## **Addendum No. 2**

### **INVITING SEALED BIDS ITB No. 21/10039**

#### **Project: West Campus Laboratories Bldg. F Renovation**

**Issue Date:** February 18, 2021

VOLUME III  
SHEET NO.  
**F5**  
OF

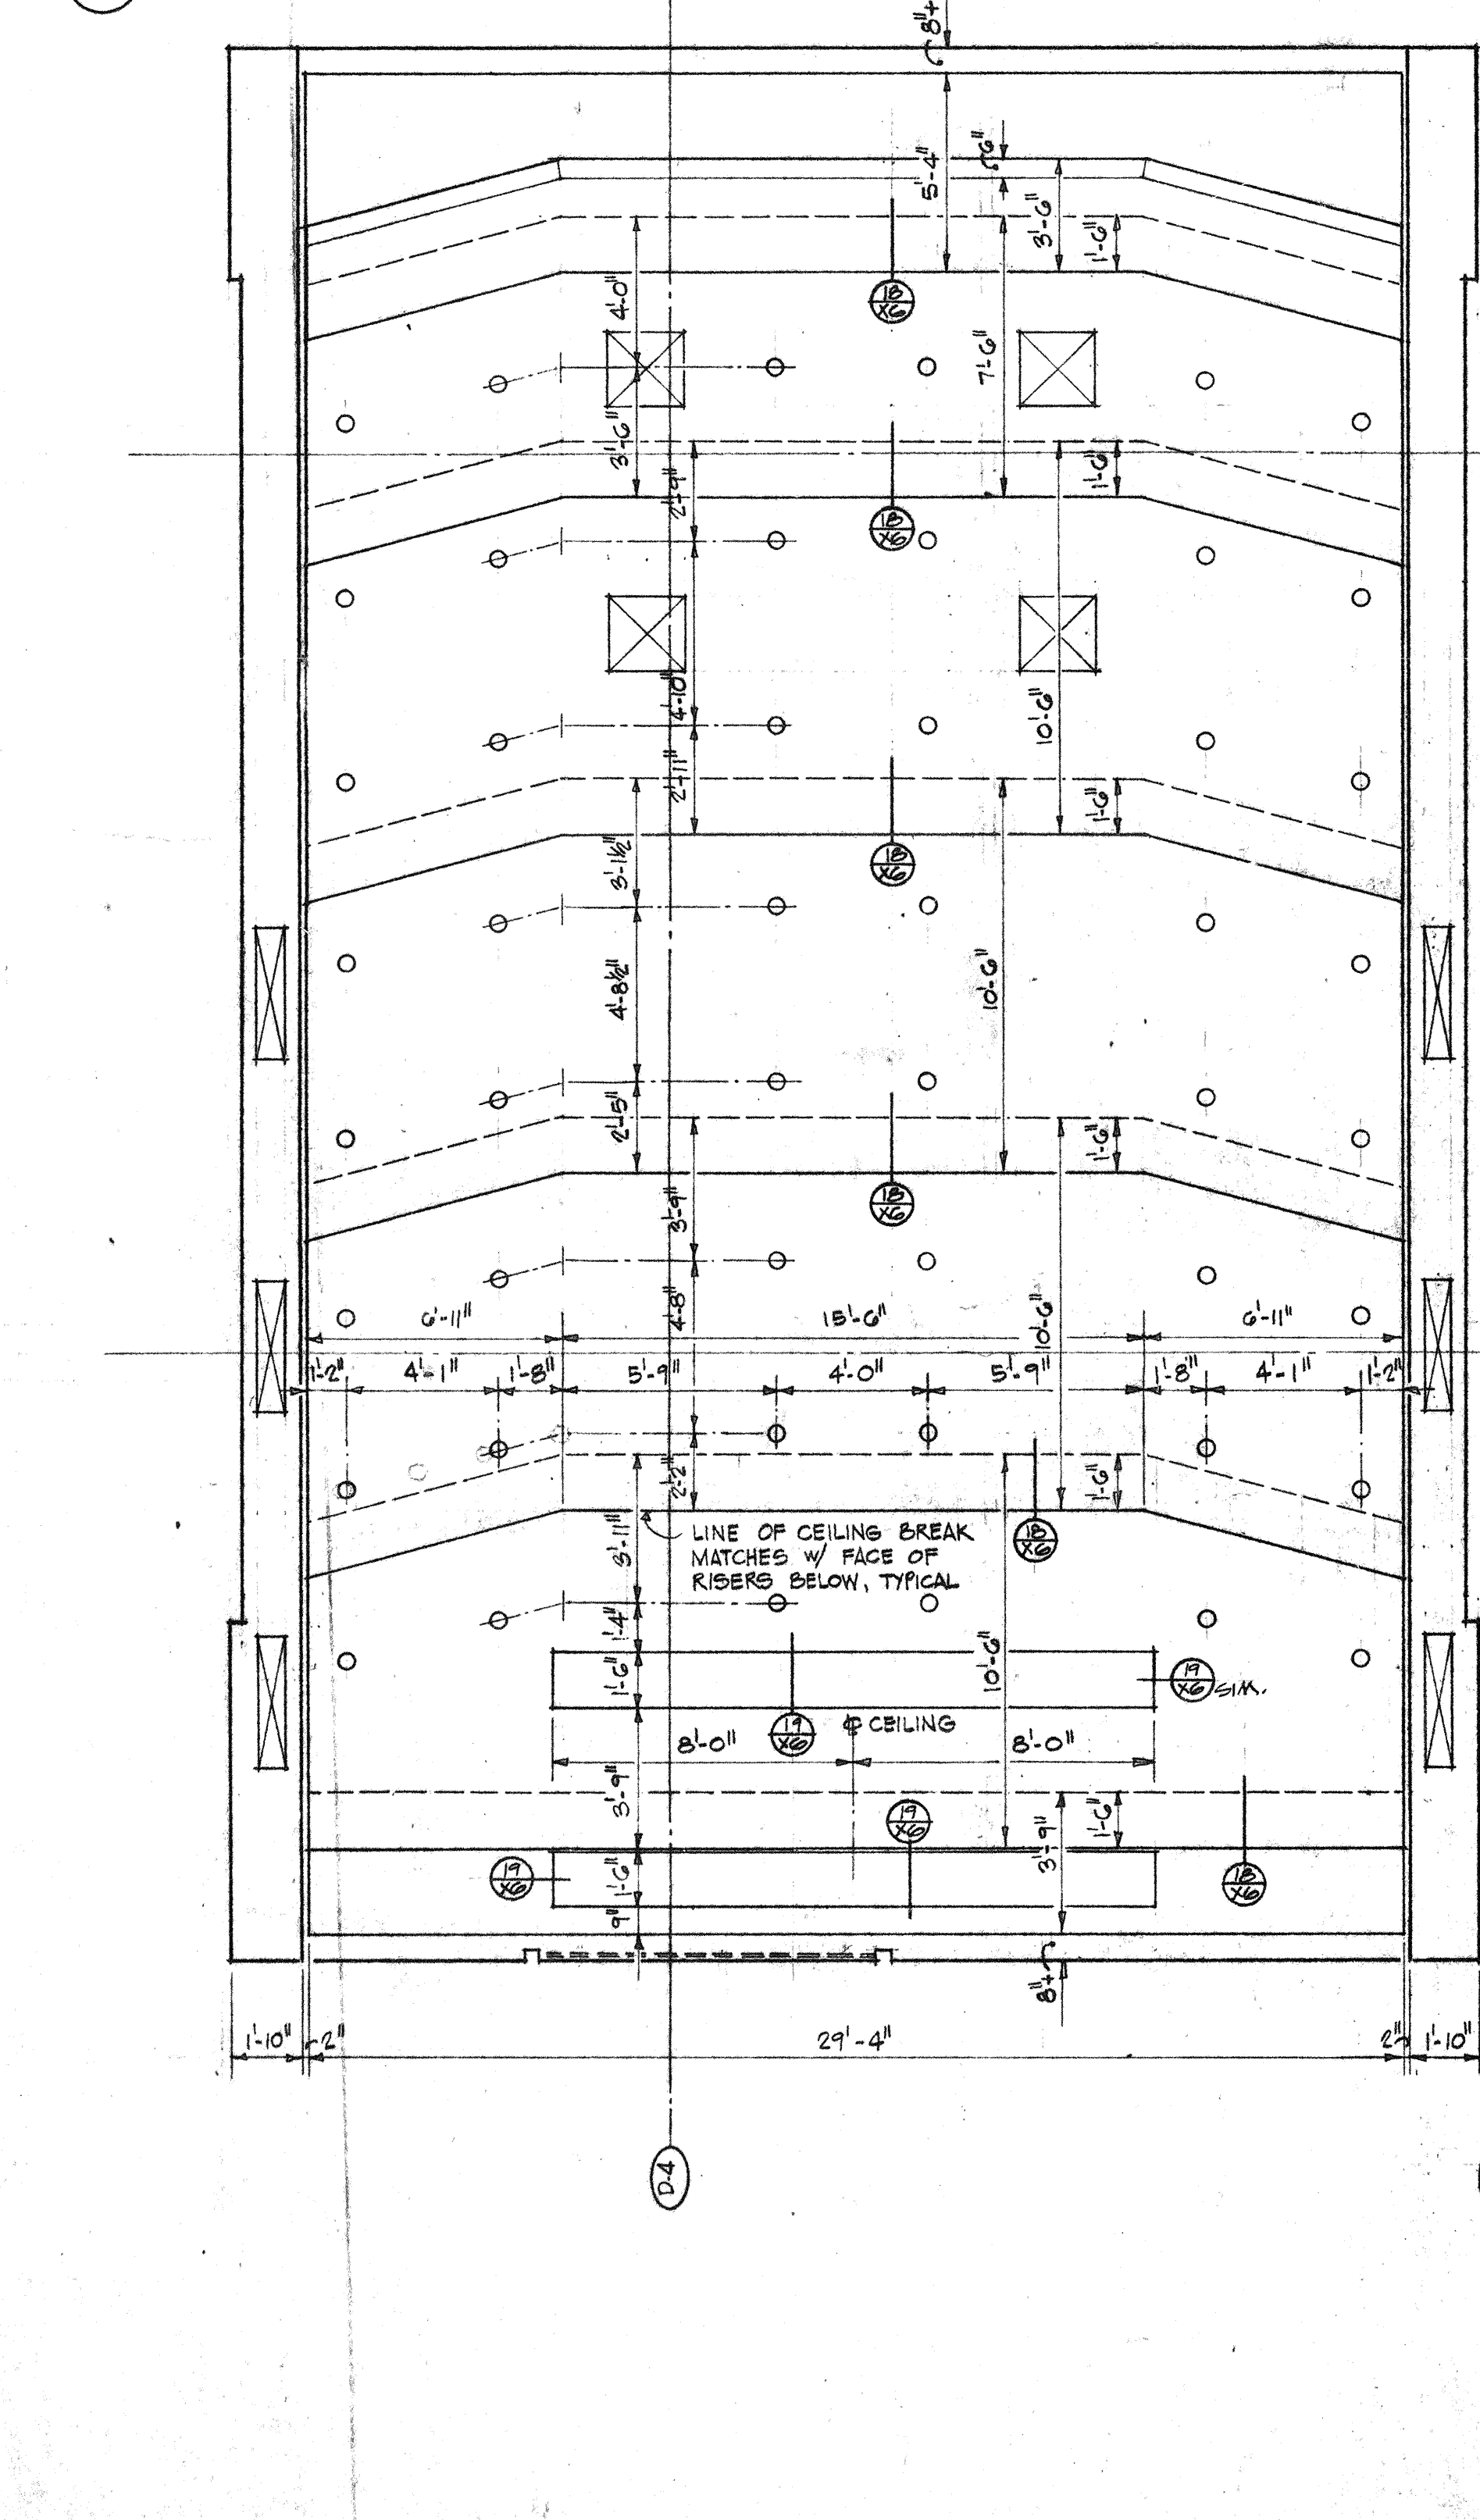
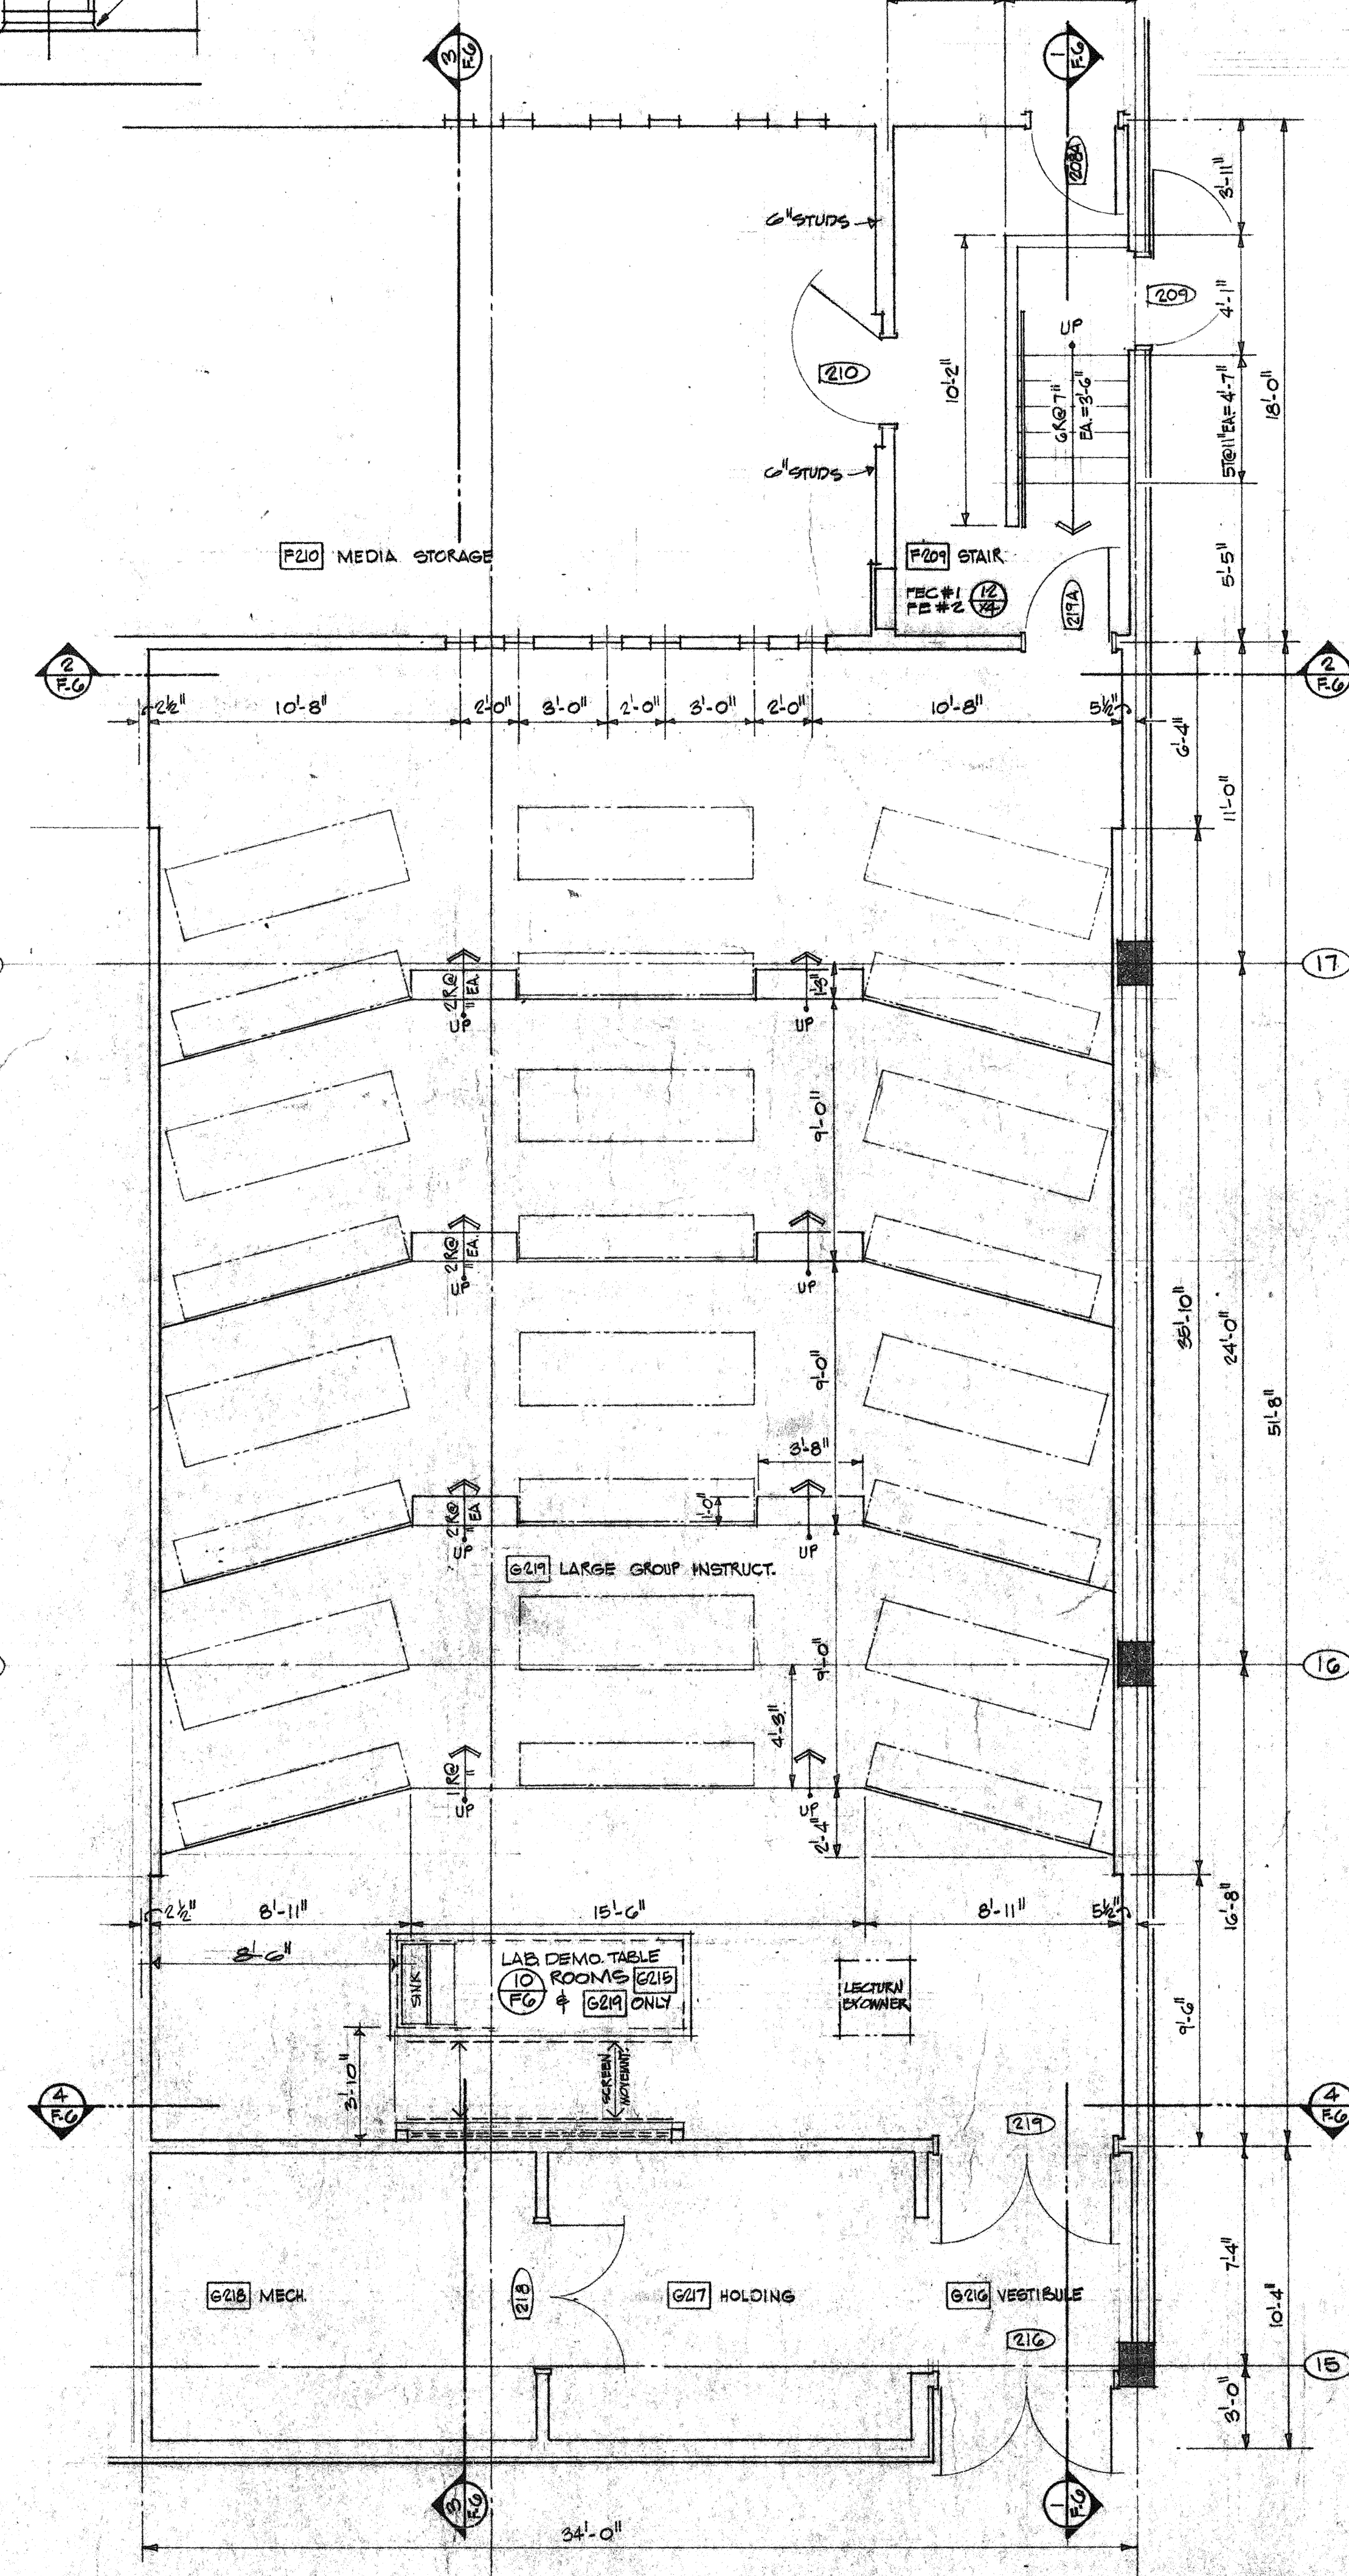
**Answer #5:** Roof Warranty is attached.
- Question #6:** Can As Built drawings of floor risers be provided to Contractors? What materials are the floor risers made of?

**Answer #6:** As built drawings F5 & F6, L GI DETAILS, have been added to the Addendum. Materials are called out on these drawings.
- Question #7:** Are the exterior Honeywell cameras to be salvaged?
